**STATE SIGNIFICANT DEVELOPMENT:
Section 96(2) Modification Application**

**Sydney International Convention, Exhibition and
Entertainment Precinct (SICEEP), Darling Square
(formally The Haymarket), Darling Harbour**

SSD 5878 MOD2

Environmental Assessment Report
Section 96(2) of the *Environmental Planning and
Assessment Act 1979*

Figure 3: Built form massing comparison between the approved and proposed North Plot building envelope

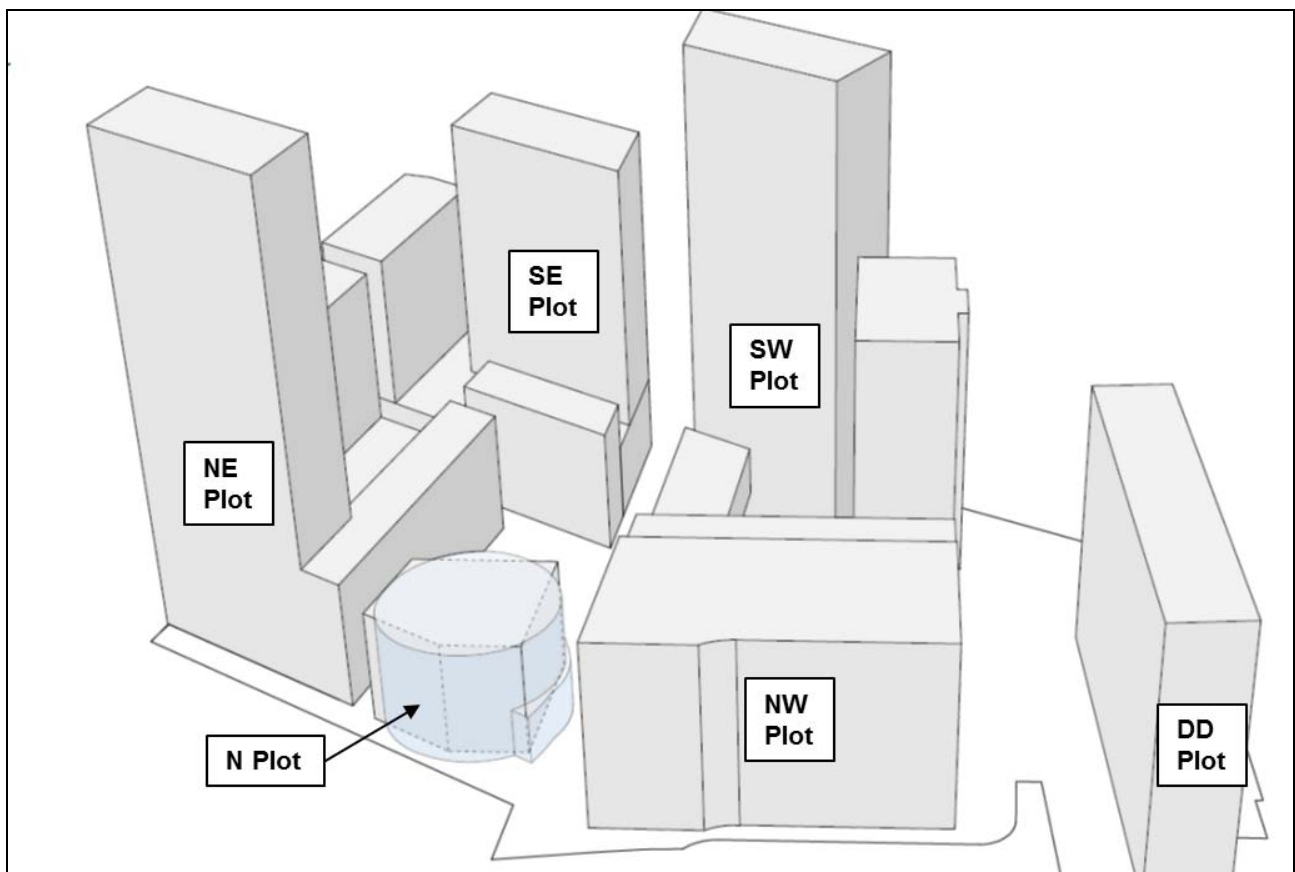
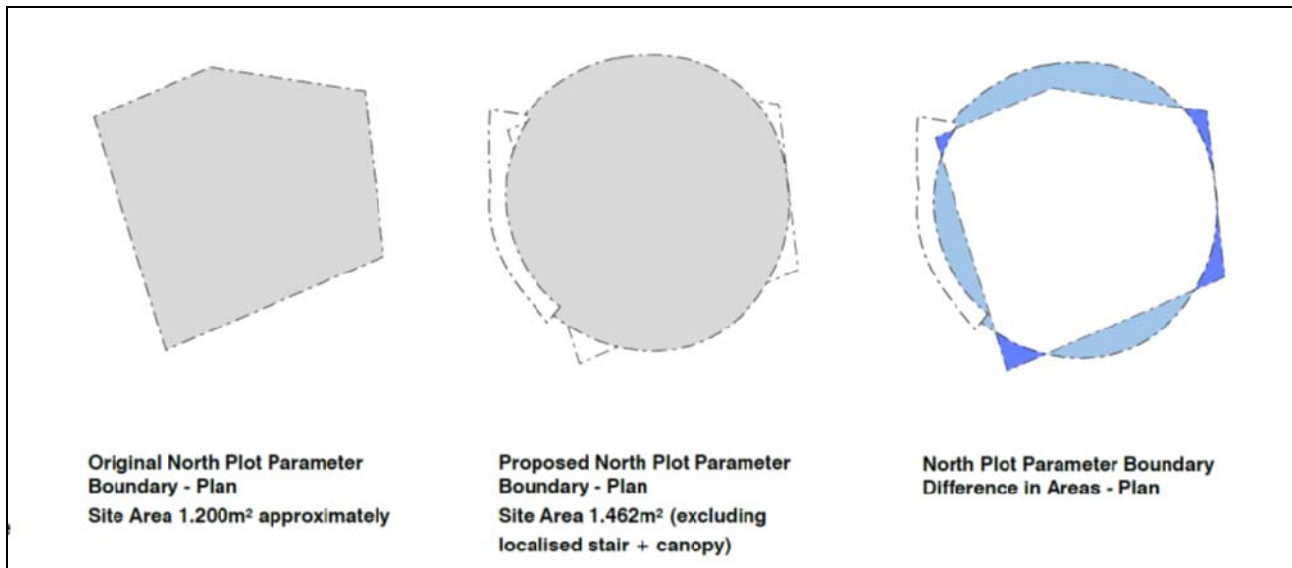
The proposal seeks to alter the shape of the North Plot building envelope from a rectilinear to circular envelope (and associated amendments to widths to reflect the new geometry) and to increase its height by 5 metres (from RL 28.5 to RL 33.5 metres) as shown at **Figure 5**.

Figure 5: Approved (top) and proposed modified (bottom) separation distances between the North Plot and North East and North West Plots

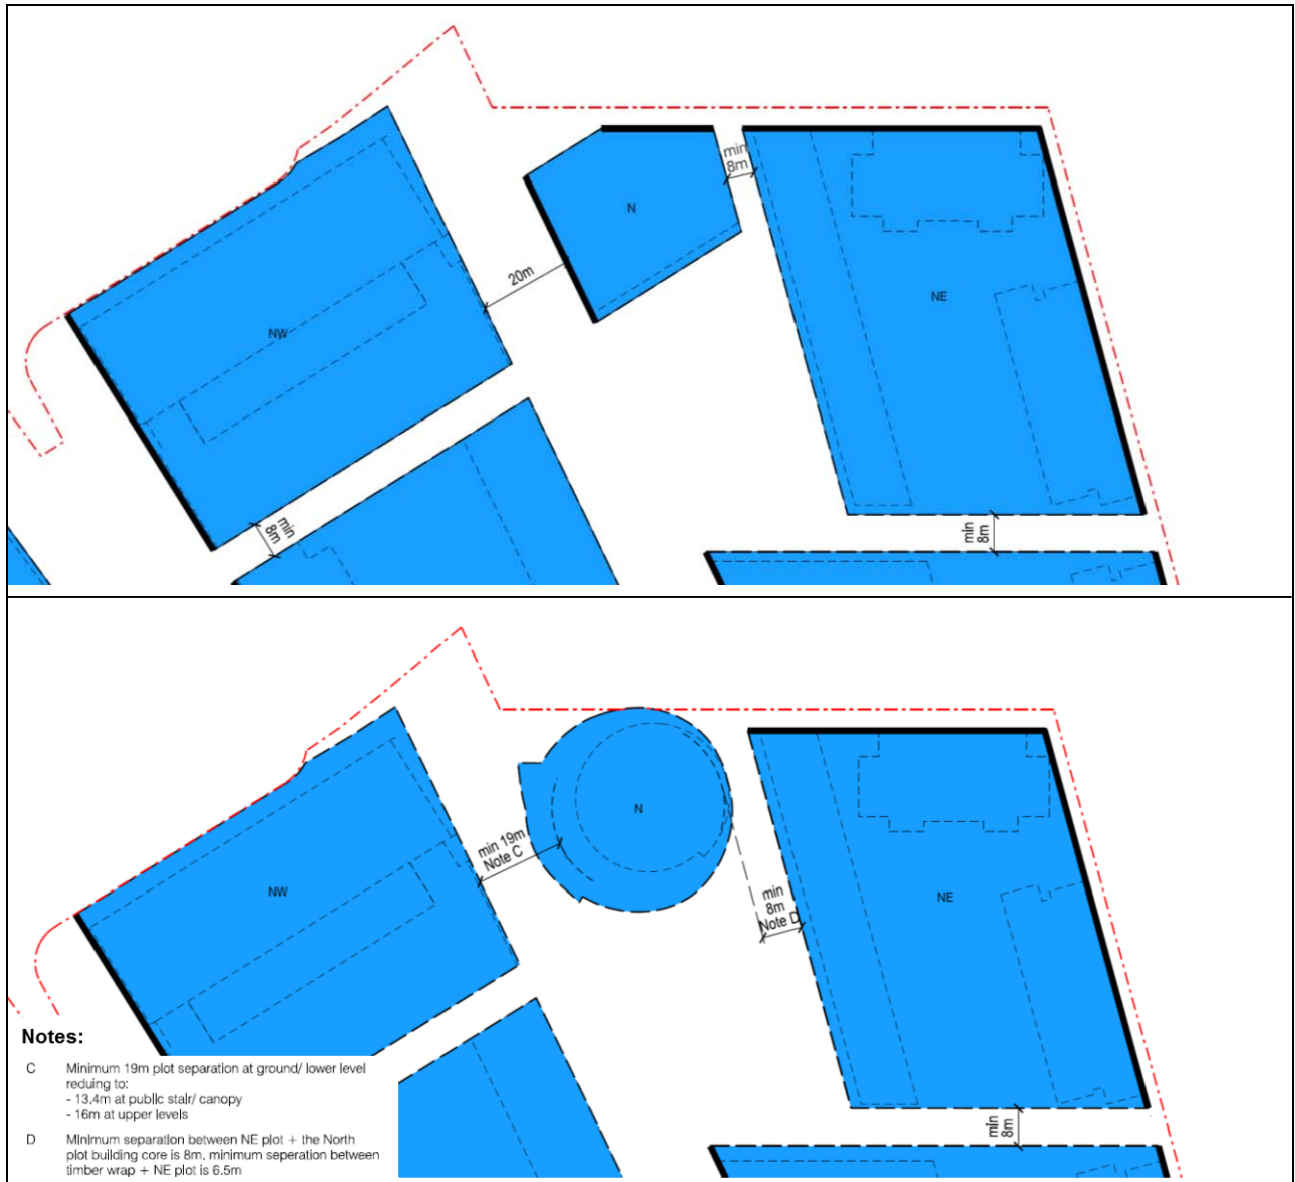
The modification seeks to reduce this separation between the North and North West Plot building envelopes to 19 metres at ground floor level, 13.4 metres at public stair/canopy level and 16 metres at upper levels (refer to **Figures 5** and **7**). The Department notes this alteration results in the North Plot building envelope projecting into the 20 metre width of the boulevard and therefore interrupts the consistent north/south view-line along the boulevard.

The Department considers the reduction of the North and North West Plot building envelope separation, and its encroachment into the boulevard, is acceptable as:

Figure 7: Proposed North and North West Plot building separation and relationship to the boulevard

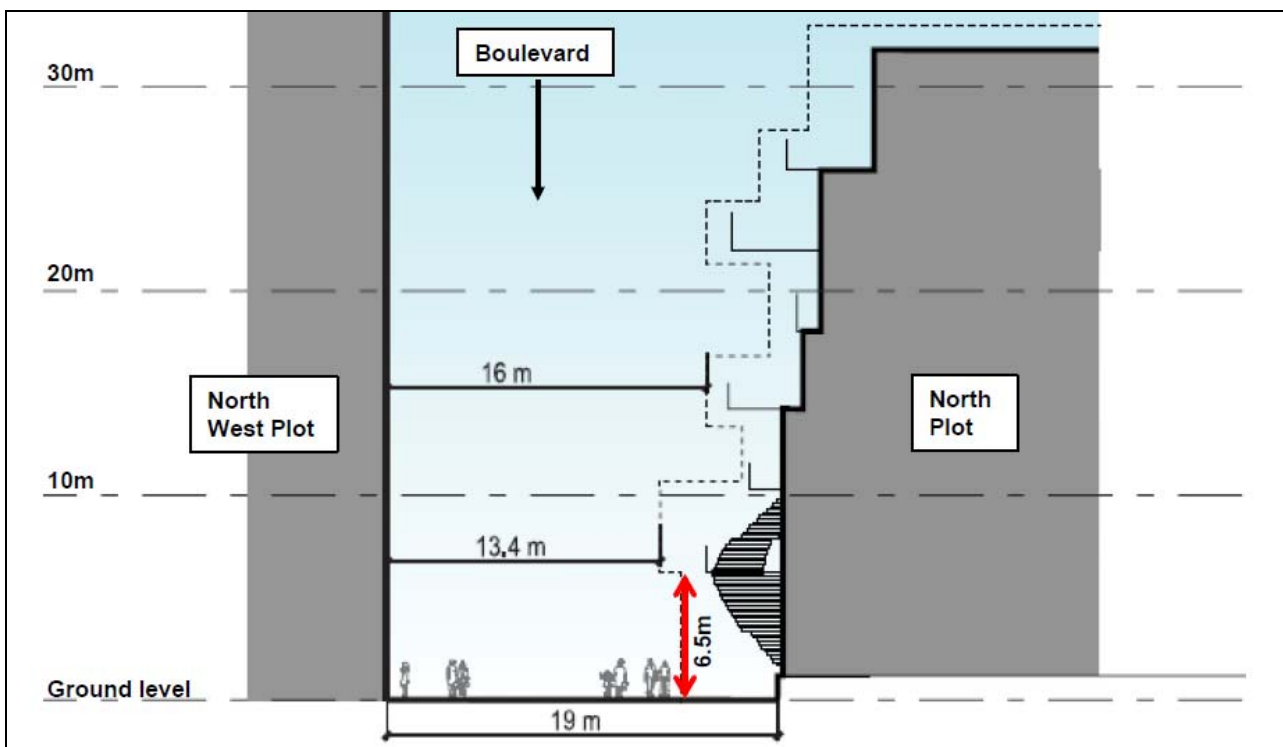
However, the Department is concerned the encroachment of the North Plot building envelope into the boulevard at the lower levels (up to a height of about 6.5 m above ground level, as shown on **Figure 7**) would materially impact the integrity of the design quality and function of the boulevard. In particular, the wrapping stair structure at this lower level would impact upon north / south views along the boulevard for pedestrians and has the potential to impede the intended open sense of pedestrian connectivity afforded by the approved boulevard space (refer to **Figure 8 and 9**).

The Department therefore recommends a condition requiring amended drawings and Design Guidelines showing an uninterrupted 19 m building separation width for the boulevard between the North Plot and North West Plot buildings up to height of 6.5 m.

Notwithstanding, the Department notes that some minor projections into the uninterrupted 19 m building separation maybe be required at the lower levels of the North Plot. In this regard, the Department recommends a condition requiring that any minor encroachment of the North Plot building into the 19 m separation be considered as part of future development applications for this building, where it has been demonstrated that:

- the encroachment does not restrict pedestrian sightlines looking north / south the boulevard;
- pedestrian connectivity along the boulevard is not adversely affected;
- the perception of openness and width of the boulevard is maintained for pedestrians;
- any encroachments are designed to be lightweight and visually permeable; and
- any encroachments does not result in an unacceptable visual pinch-point along the boulevard.

Figure 10: Comparison of the North Plot shadow cast during the Winter Solstice at noon (shaded in pink)

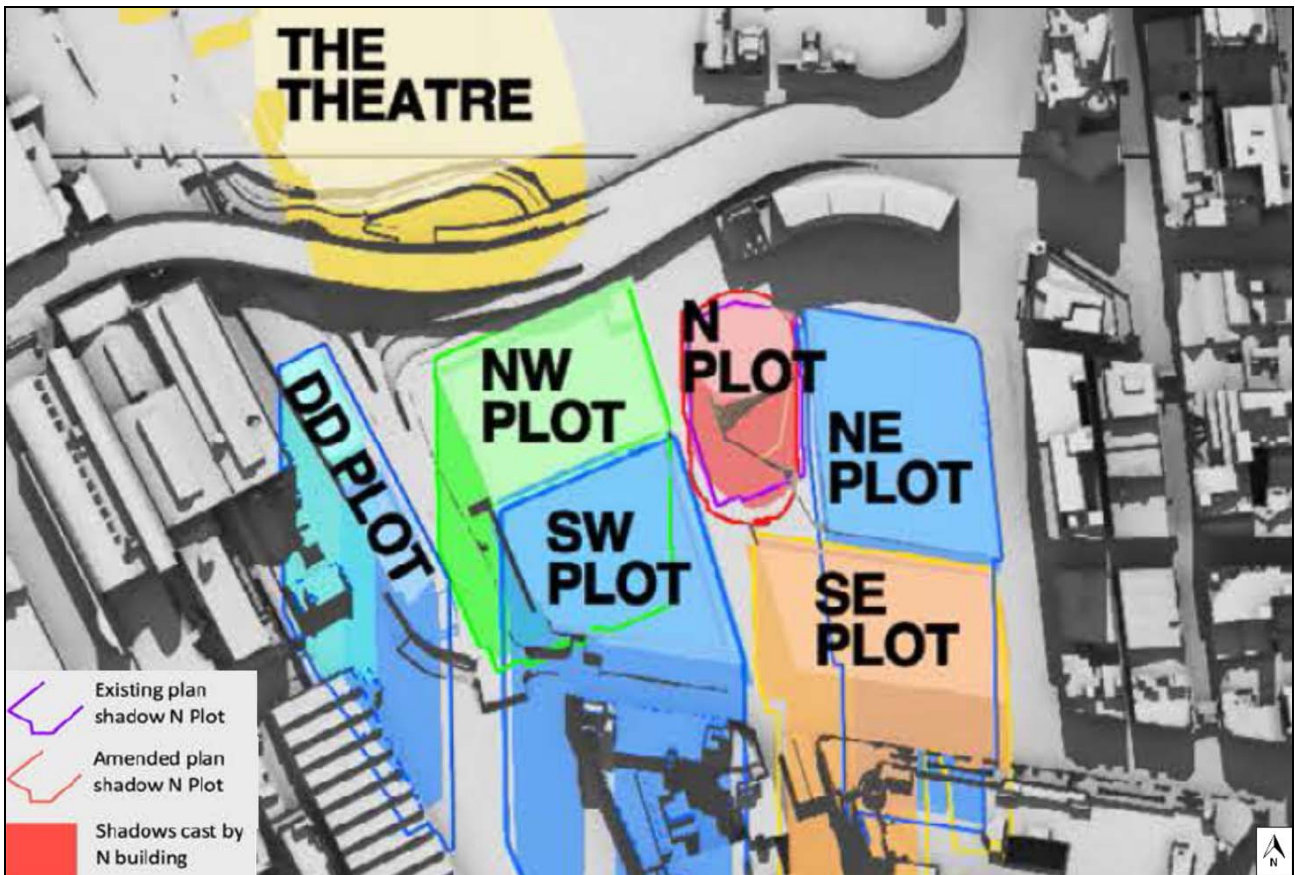
The modification includes a 5 metre increase in the proposed height of the North Plot building envelope (from RL 28.5 to RL 33.5 metres). Shadow diagrams have been provided with the application, which compare the approved and modified situation (**Figure 10**).

The Department notes the shadow diagrams submitted with the application show the shadows cast by the circular shaped North Plot building envelope:

- would be largely contained within the maximum shadow cast by the approved rectilinear shaped building envelope; and
- ensure the southern portion of the public open space would continue to achieve direct sunlight between 11:30 am and 1:30 pm in mid-winter.

- the shadow studies submitted with the proposed modification demonstrate the proposal has a negligible impact on solar access to Darling Square open space (Figure 10);
- the amended form of the North Plot building envelope (from rectilinear to circular) generally allows for additional access to sunlight surrounding the building;

Figure 11: Indicative images showing a 20% reduction of GFA at each level

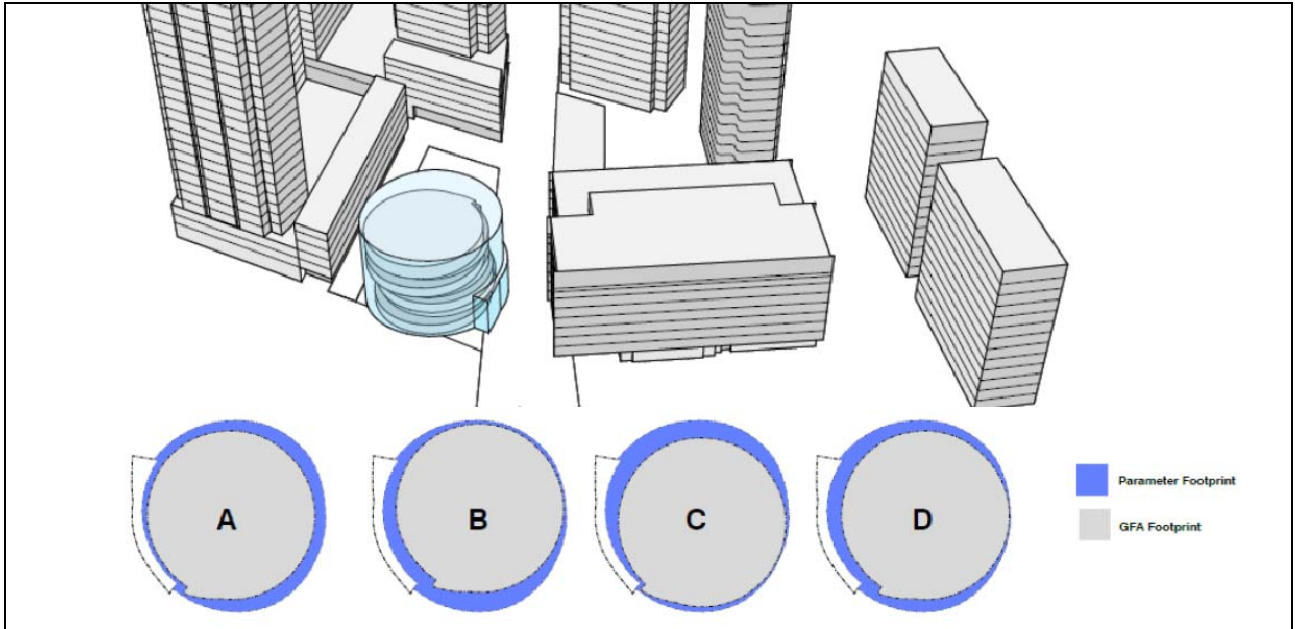
- the Design Guidelines include a requirement that the future building within the North Plot includes a minimum 20% reduction of parameter footprint of GFA at each level, which ensure the future building within the North Plot is of a lesser scale than the maximum size of the North Plot building envelope;
- the indicative design of the North Plot building includes cantilevered levels, which would allow for additional sunlight to penetrate through to the open space in winter months; and
- the revised height matches the maximum podium building envelope heights surrounding the Darling Square open space.

Figure 12: Minor adjustment to the northern site boundary

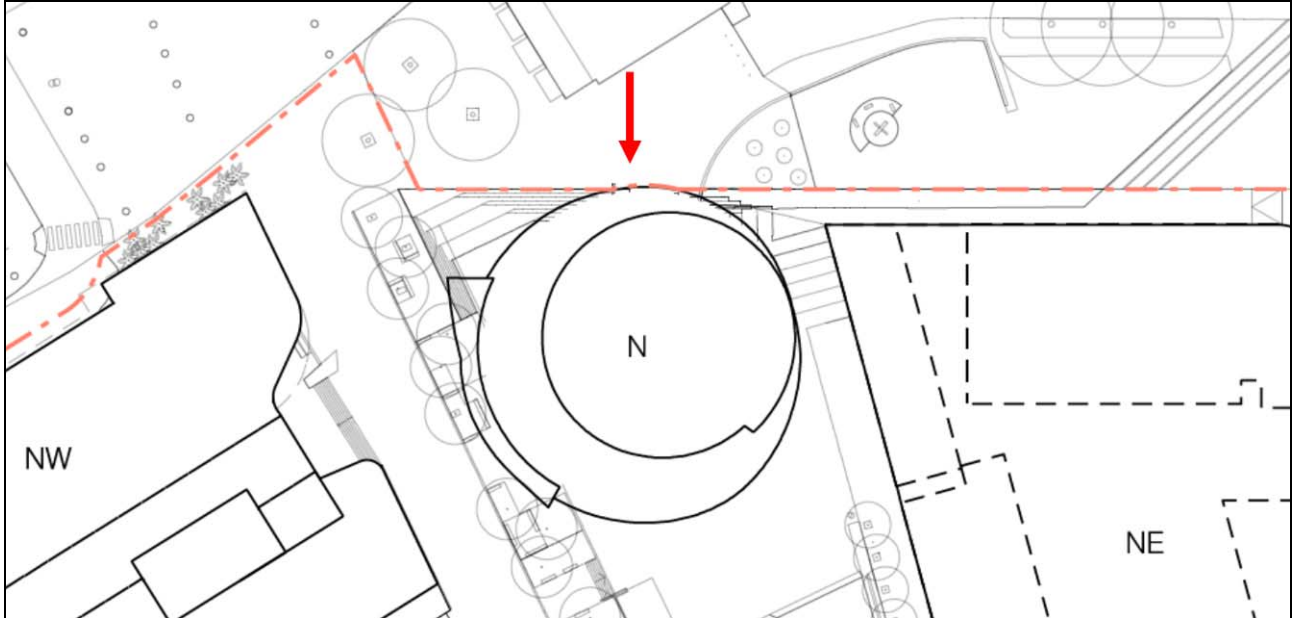
The proposal includes a minor adjustment of the northern site boundary to accommodate the curved building envelope of the North Plot (refer to **Figure 12**), which results in an overall increase in the site area of 1.3 m². Therefore the Department considers the proposed amendment to be minor and administrative in nature and is acceptable.

Figure 13: Updated Illustrative Development Staging Diagram

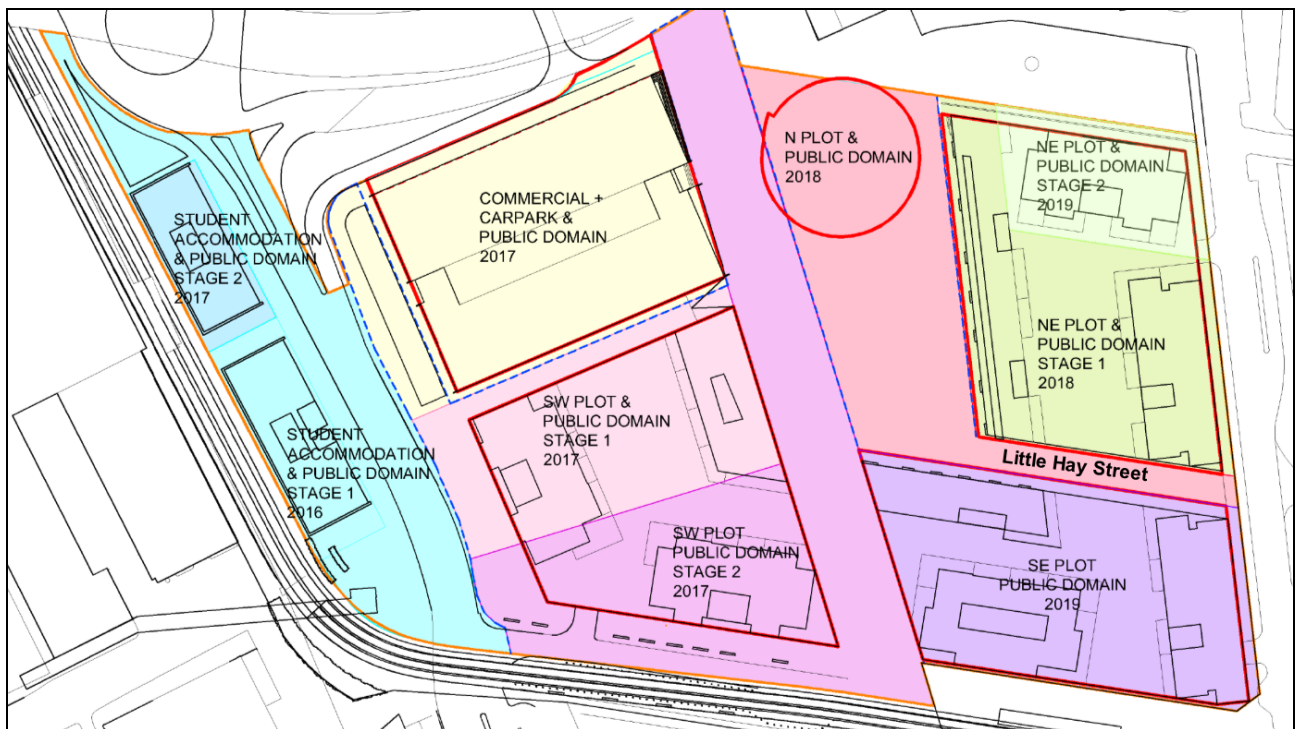
The proposal includes an amended IDSD, which proposes the delivery of the Little Hay Street public domain as part of the North Plot and public open space stage and the consolidation of the South East Plot stages into one stage as shown in **Figure 13**.

The Department considers the revised staging of the development is acceptable as:

- it ensures all of Little Hay Street is constructed in one stage and three years sooner than originally anticipated (in 2018);
- it is appropriate the key community and open space benefits in the North Plot are delivered at the same time as the Little Hay Street public domain, which provides an important east/west link to Chinatown and the CBD; and
- the consolidation of the two stages of construction of the South East Plot will reduce construction time by approximately seven years (completion in 2019), which will reduce potential impacts of construction on the surrounding area.
